Proposed Change to Appendix A
Technical Specifications to
Operating License DPR- 25

Revised page: Sheet 2 of 5 of Figure 3.5-1

Dresden Unit 3
Fuel Type 8DRB265L
and P8DRB265L (Dashed Line)

VERSUS PLANAR AVERAGE EXPOSURE
Sheet 2 of 5 of Figure 3.5-1

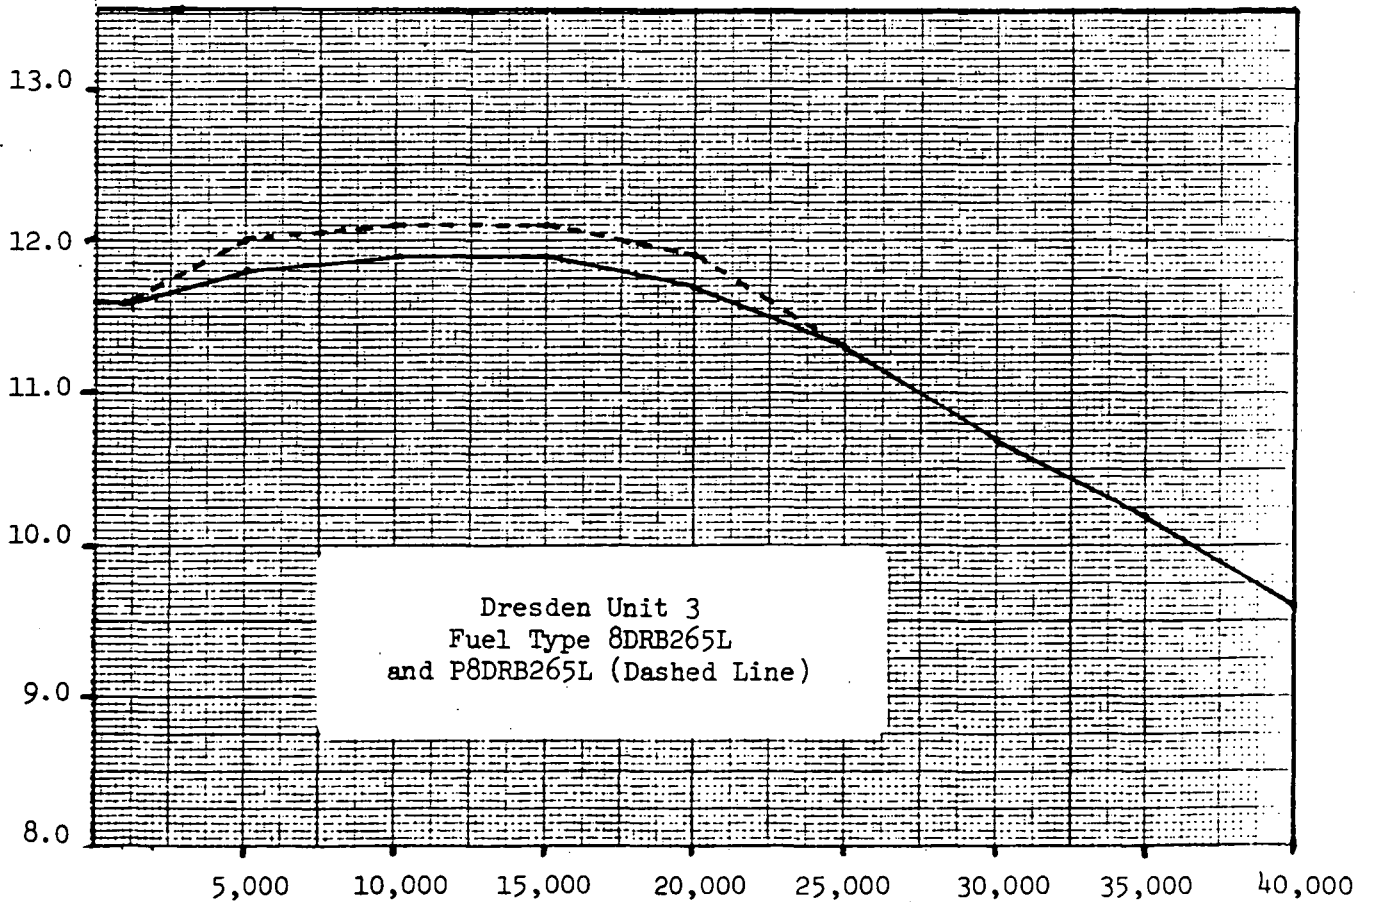
Due to an oversight on CECO's part, we overlooked the need to extend MAPLHGR curves from 30,000 to 40,000 MWD/ST for certain fuel types during Dresden Unit 3 Cycle 9. This amendment request reflects these changes.
